## Application for a Non-Material Amendment – Rev B

### Ground & Basement Floor, 4 - 5 Centric Close

This application has been prepared by Daniel Watney LLP seeking a non-material amendment to application 2020/0187/P at 4-5 Centric Close, London, NW1 7EP.

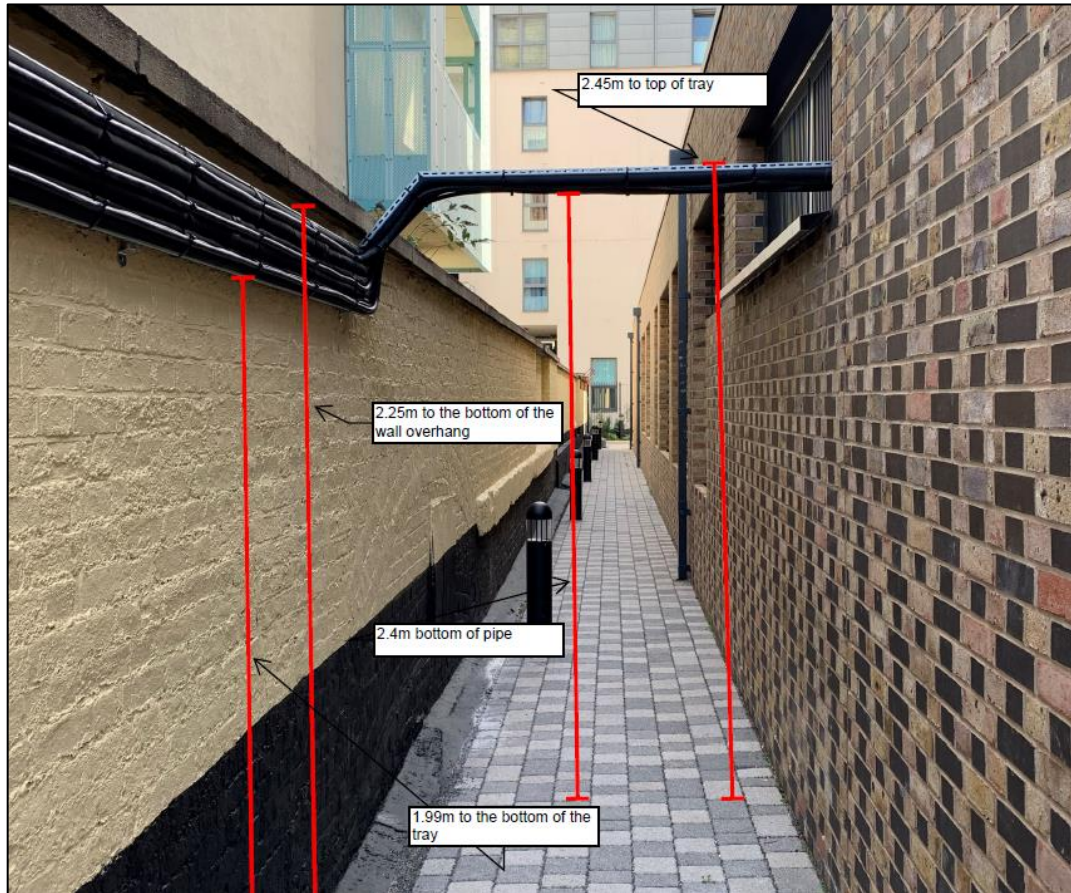
The original planning application secured permission for the installation of an acoustic enclosure running along the western boundary of the site, adjacent to the railway as identified in Figure 1 below. Ahead of the implementation of the scheme, it became clear that this location clashed with some soft landscaping that the landlord was delivering as part of the wider redevelopment subject to planning permission 2016/6891/P.

Therefore the location of the enclosure itself needed to be reconfigured 90 degrees to run alongside the northern wall instead to accommodate both the enclosure and the soft landscaping works.

The enclosure is the same dimensions as that approved previously, it has simply rotated 90 degrees and still sits below the boundary walls so would not be visible from surrounding locations.

The detailed design also requires amendments to the refrigerant pipework running from the commercial unit to the acoustic enclosure.

The original drawings attached to the permission stated that the pipework would run underground however the construction team were required to re-visit this for the following reasons and the preference now is to keep the pipework above ground level:

- Buried or underground piping on Heating, Ventilation and Air Conditioning (HVAC) systems is not recommended where it can be avoided;
- Refrigerant flood back: running refrigerant piping underground invites the accumulation of liquid refrigerant in both lines, especially the suction line, due to the cooling provided below ground level. Liquid in the suction line can cause liquid slugging at the compressor motor that ultimately destroys the compressor;

- The pipework is open to corrosion and leaks when underground. This is also an issue with accessibility and dealing with a leak should one arise.
- Refrigerant lines must be installed below the frost line. The depth required past the frost line depends on the amount of foot traffic that may pass over the line. In this case, the underground route is under a main fire escape. In the event of an emergency, 40+ persons may use this route as a means of escape.

- Load bearing trunking would also need to be installed in both a single piece and made watertight.
- The route is also encumbered by a manhole, assumed use as a rodding point for the internal/external drainage.

It is now proposed that the 6 small pipes exit the building through the northern elevation, stepping up to 2.45m above ground level to cross the external walkway / emergency

access. This then arches down to the party wall, running along to the condensers at 2.35m above ground level hidden under the wall capping so not visible externally. The pipework will be clipped to tray running along this northern wall, all shown in the mark-up below.
